AGENDA FOR REGULAR MEETING VILLAGE OF TINLEY PARK PLAN COMMISSION

**Item #2 WORKSHOP: TWO MEN & A TRUCK-7420 & 7430 DUVAN DRIVE
SITE PLAN APPROVAL WITH VARIATIONS**

Consider granting approval of a Site Plan with landscape waivers for the Petitioner, Paul Brown of Two Men and a Truck, to construct a parking lot and detention facilities on properties in the ORI MU-1 Zoning District with the common addresses of 7420 & 7430 Duvan Drive.

SITE PLAN

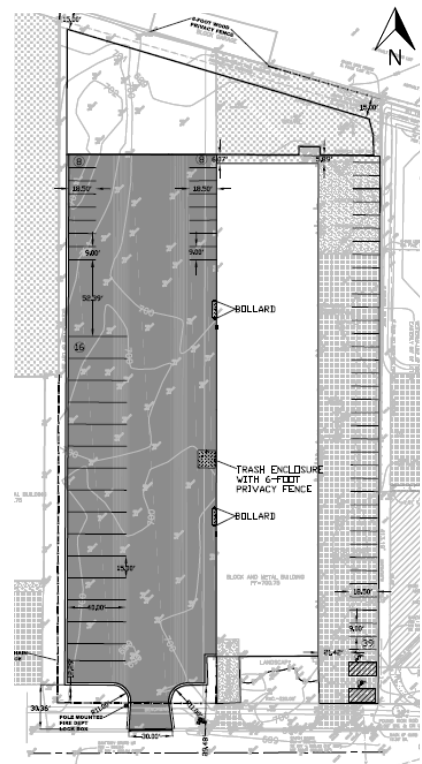
Open Item #1: The Petitioner has decided not to consolidate the two (2) lots and instead place deed restrictions on them. Consideration should be given to a condition requiring the consolidation of the lots within a certain time frame that would not delay the business opening. Staff also recommends conditions requiring the removal of the parking lot and installation of grass be placed on the Site Plan and Variation approvals.

Open Item #2: A final draft of the deed restriction language must be reviewed by the Village's planning staff and attorney prior to the public hearing. Staff recommends a condition requiring that the deed restriction be recorded prior to any building permit approvals.

LANDSCAPE & FENCING

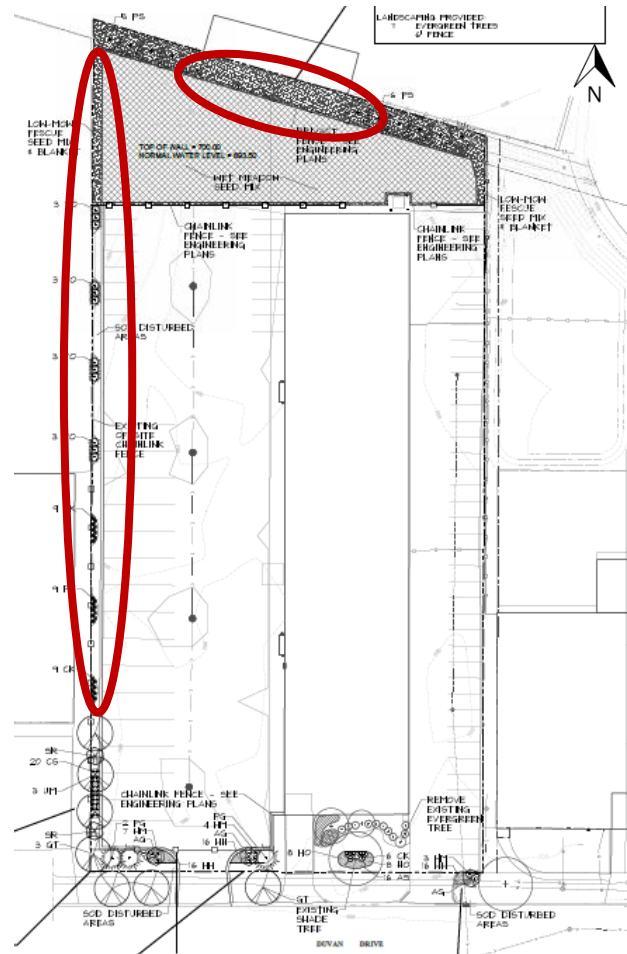
While some canopy and buffer trees have been added, there are some additional areas that canopy and shade trees can be placed to meet the bufferyard requirements and help offset the loss of interior parking lot landscaping and trees. Staff recommends adding trees along the north property line to continue the visual buffer of evergreen trees to block visibility of the site from the residences and along the west property line that has only proposed arborvitaes and tall grasses (see image).

Open Item #3: Discuss the proposed landscape plan and additional landscaping that might help to meet the intent of the bufferyard and interior parking lot landscape waivers being requested. Additional tree coverage along the north and west property lines is recommended.

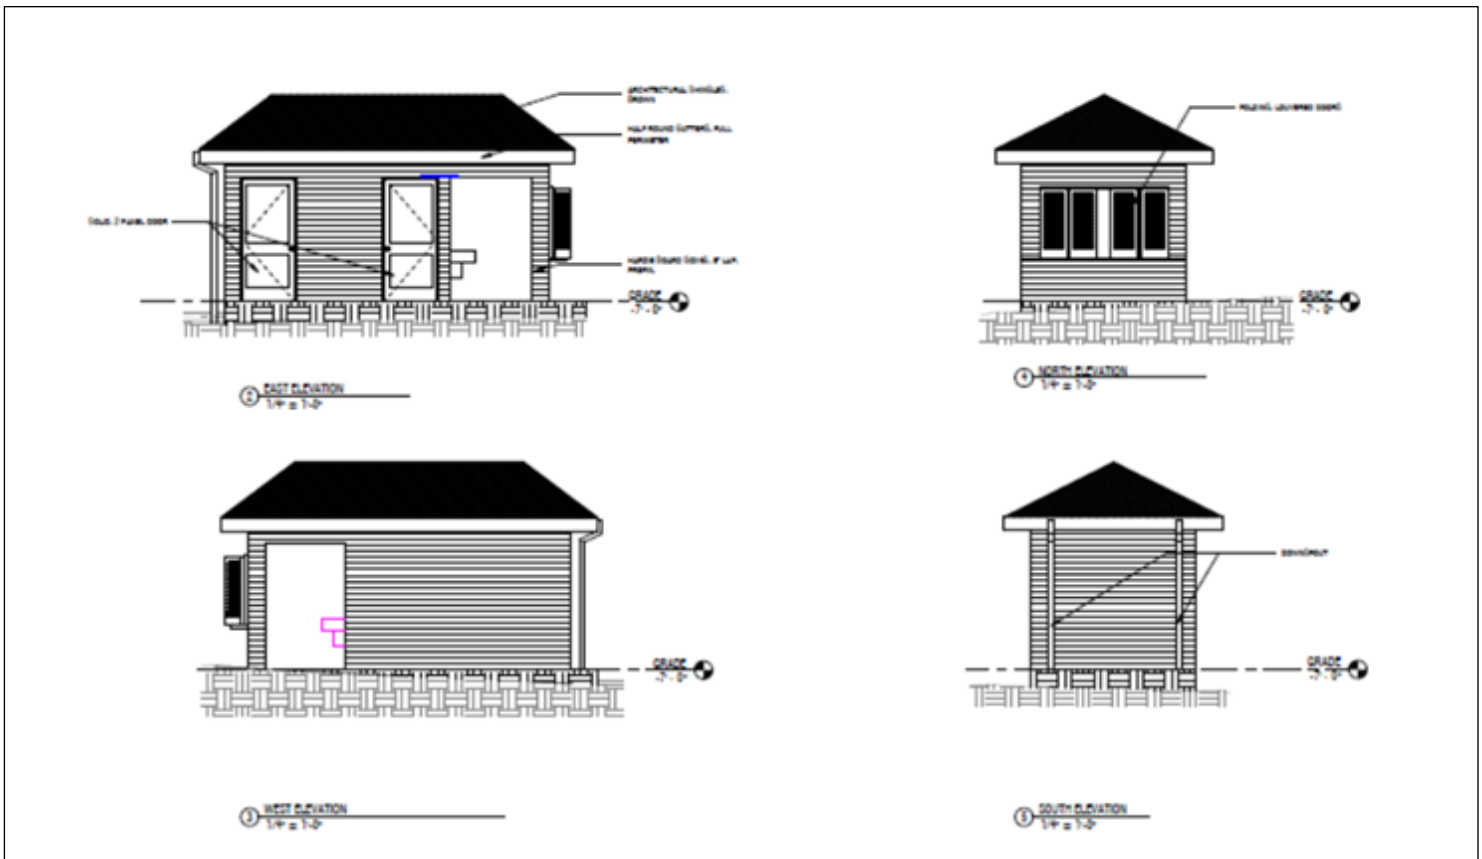
8. CHAIRMAN SHAW noted the Commission has 2 open seats hopefully will be filled shortly. Ms. Clarke replied the Village Board will be appointing on July 17, 2018

COMMENTS FROM THE COMMISSION
